CAPE COD COMMISSION

RE: Modification of a Development of Regional Impact Hardship
Exemption Decision dated July 23, 2009

PROJECT: Haseotes Addition

MODIFICATION OF DEVELOPMENT OF REGIONAL IMPACT DECISION

SEPTIC SYSTEM DESIGN
293 LONG BEACH ROAD
CENTERVILLE, MA.
PREPARED BY: P.M.P. ASSOCIATES, LLC

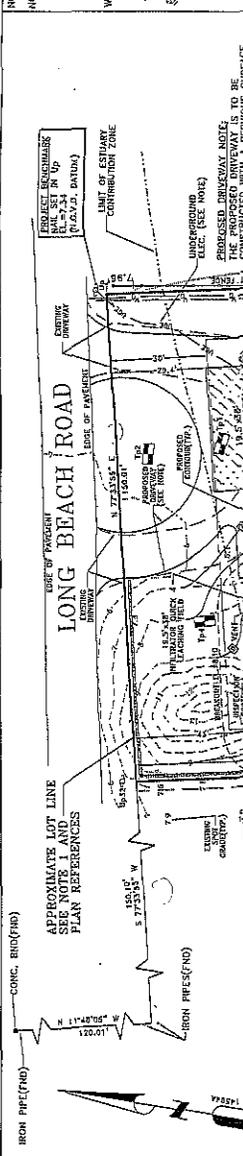
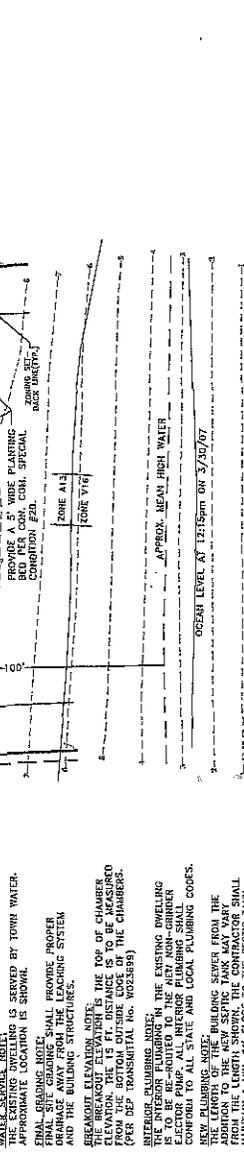
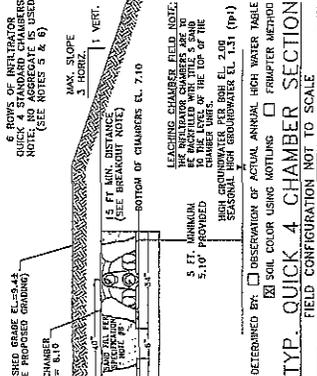
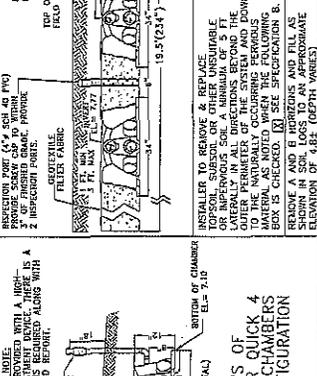
- WRC3. The Applicant shall install a FAST® denitrifying septic system as shown on Septic System Design plan, prepared by P.M.P. Associates of East Bridgewater, MA (dated April 27, 2007 with latest revision dated **September 8, 2009** ~~June 2, 2009~~) and in accordance with the High Strength Fast 1.0 Septic System Design Details plan, prepared by P.M.P Associates (dated December 11, 2008 with latest revision dated June 2, 2009). The soil absorption system shall be located outside the Centerville River watershed mapped as described in WRF5.
